## STAFF REPORT

APPLICATION SEA 01-M-017

**APPLICANT:** Arlington Virginia Federal Credit Union

**LOCATION:** 5666 Columbia Pike

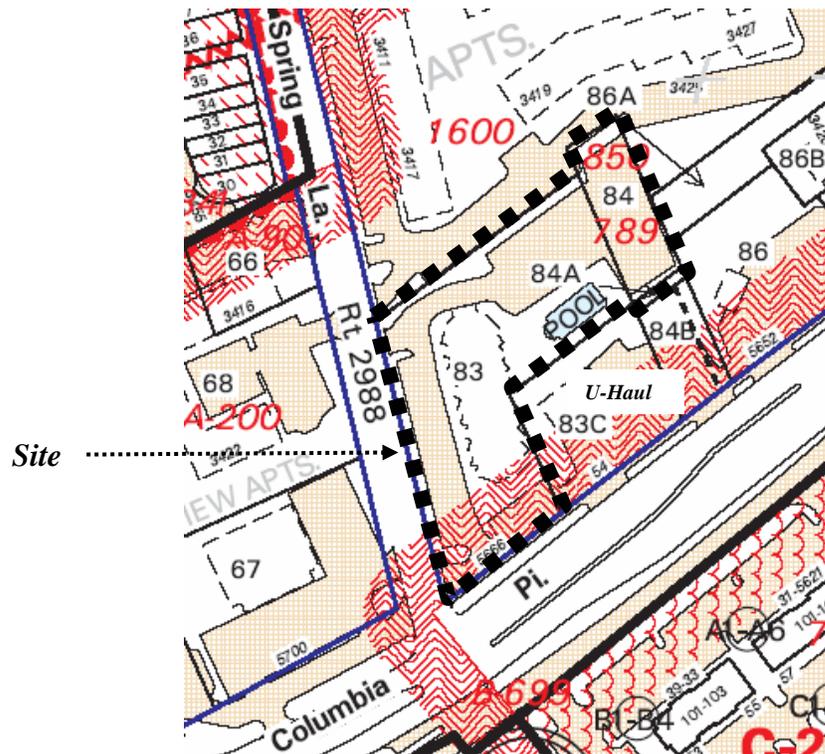
The application property is located at 5666 Columbia Pike, in the northeast quadrant of the intersection of Columbia Pike and Spring Lane. The site is currently developed with a three to four story motel (circa 1961), which includes a vehicle rental establishment, and is to be demolished with the proposed redevelopment. The existing hotel has an FAR of 1.0, and a height of approximately 36.5 feet (4 stories) as measured on the Columbia Pike end and 25.5 feet (3 stories) on the north end of the building, adjacent to the residential use to the north. Access to the site is currently provided by two entrances on Spring Lane and a service drive along Columbia Pike, which is located in an easement on the property (not dedicated right-of-way). The site has a significant amount of impervious surface.

The application property consists of three parcels (all of which are currently under use for the aforementioned hotel). The site is "L" shaped, as shown below, with the short leg of the site fronting Spring Lane and Columbia Pike, and the longer leg extending behind the U-Haul facility (on Columbia Pike).
